Well Name: POKER LAKE UNIT 22 DTD	Well Location: T24S / R30E / SEC 22 / NWNW /	County or Parish/State:
Well Number: 122H	Type of Well: CONVENTIONAL GAS WELL	Allottee or Tribe Name:
Lease Number: NMNM068905	Unit or CA Name:	Unit or CA Number:
US Well Number: 3001549864	Well Status: Approved Application for Permit to Drill	Operator: XTO PERMIAN OPERATING LLC

Sundry ID: 2761874

Type of Action: APD Change

OPERATOR'S NAME:	XTO Permian Operating LLC
WELL NAME & NO.:	Poker Lake Unit 22 DTD 122H
LOCATION:	Sec 22-24S-30E-NMP
COUNTY:	Eddy County, New Mexico

WELL LOCATION AND ACREAGE DEDICATION PLAT

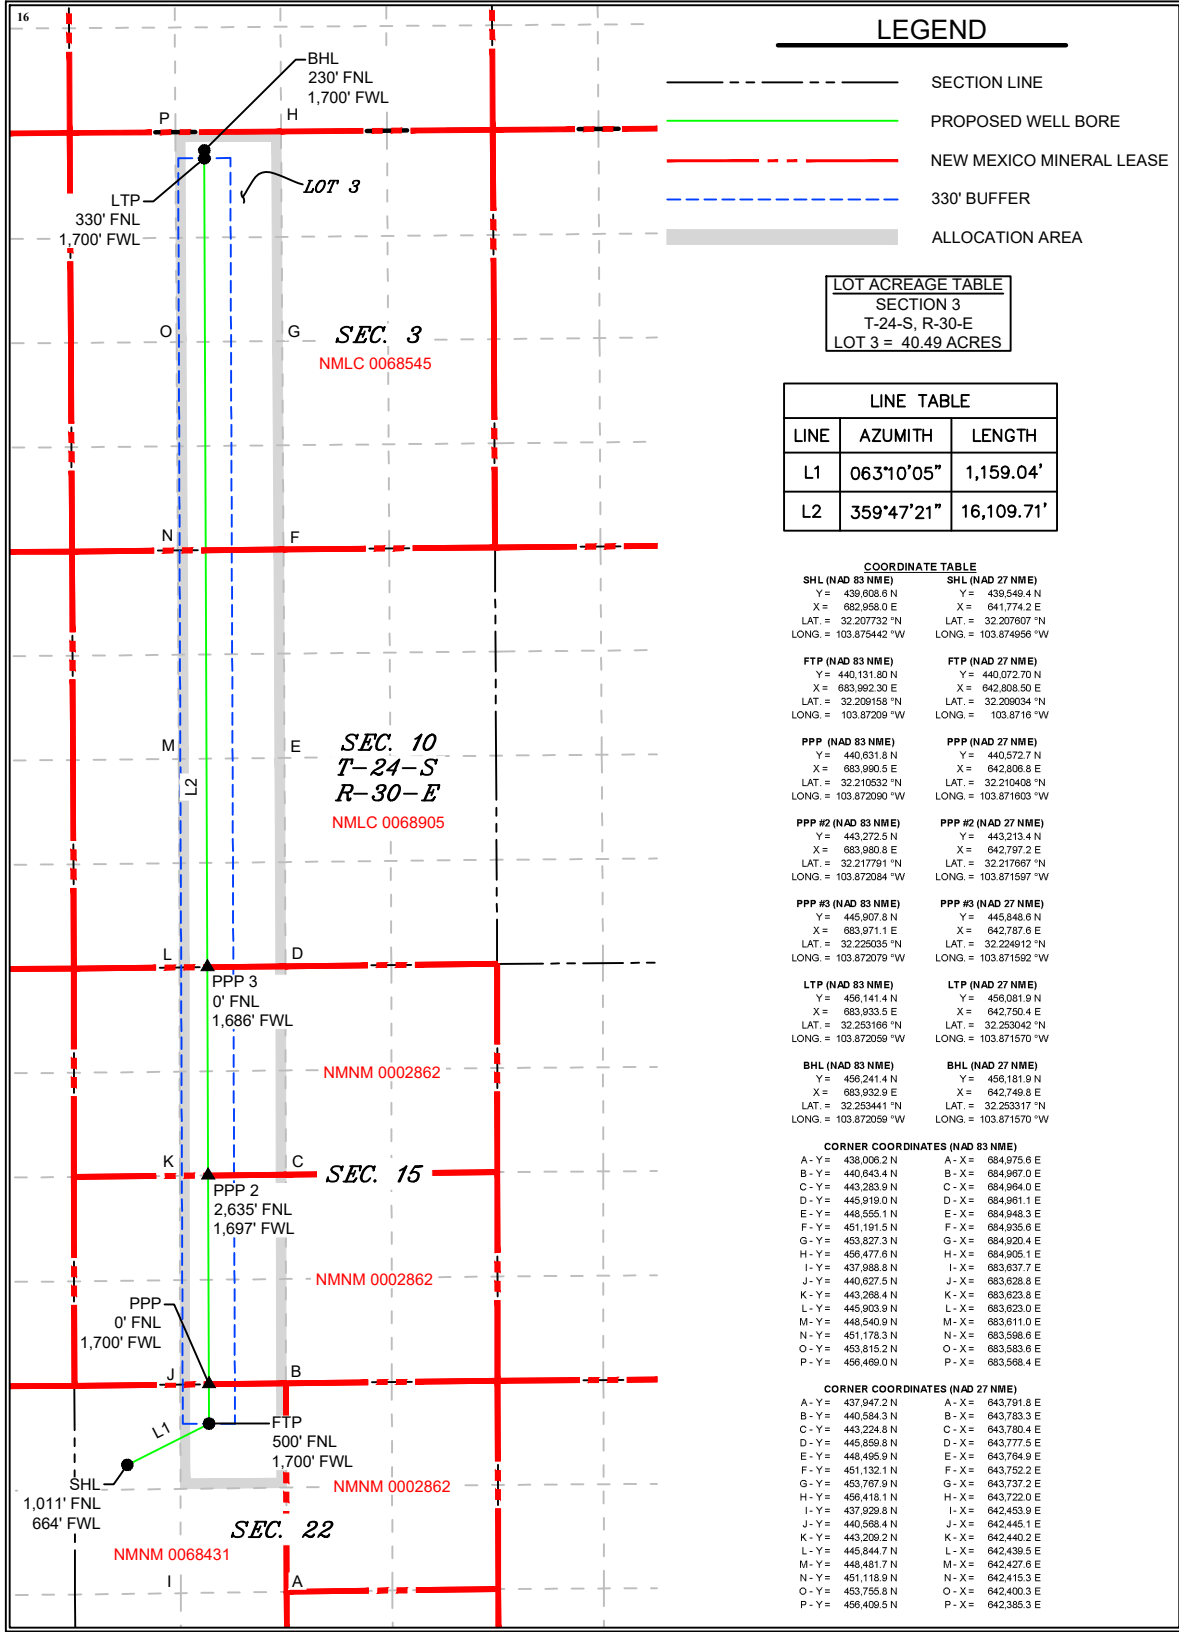
Procedure Description: XTO Permian Operating LLC. respectfully requests approval to make changes to the Approved APD as follows: SHL, BHL, FTP, LTP, Directional Drilling Plan, Casing and cement change. SHL: FROM: 1106' FNL & 175' FWL TO: 1011' FNL & 664' FWL of Section 22-T24S-R30E BHL: FROM: 200' FNL & 1634' FWL TO: 230' FNL & 1700' FWL of Section 3-T24S-R30E FTP: FROM: 100' FNL & 1577' FWL TO: 1011' FNL & 1700' FWL of Section 22-T24S-R30E LTP: FROM: 329' FNL & 1633' FWL TO: 330' FNL & 1700' FWL of Section 3-T24S-R30E DRILLING AND CASING PLAN: 6" P-110 26# production casing will be run instead of 5-1/2" P-110 23# production casing. ATTACHMENTS: New C-102, Drilling and Casing Plan, Directional Plan, Wellhead Design, Casing Spec Sheet, BOP Variance Request and Well Control Plan

¹⁰ Surface Location									
UL or lot no.	Section	Township	Range	Lot Idn	Feet from the	North/South line	Feet from the	East/West line	County
D	22	24S	30E		1,011	NORTH	664	WEST	EDDY

¹¹ Bottom Hole Location If Different From Surface									
UL or lot no.	Section	Township	Range	Lot Idn	Feet from the	North/South line	Feet from the	East/West line	County
3	3	24S	30E		230	NORTH	1,700	WEST	EDDY
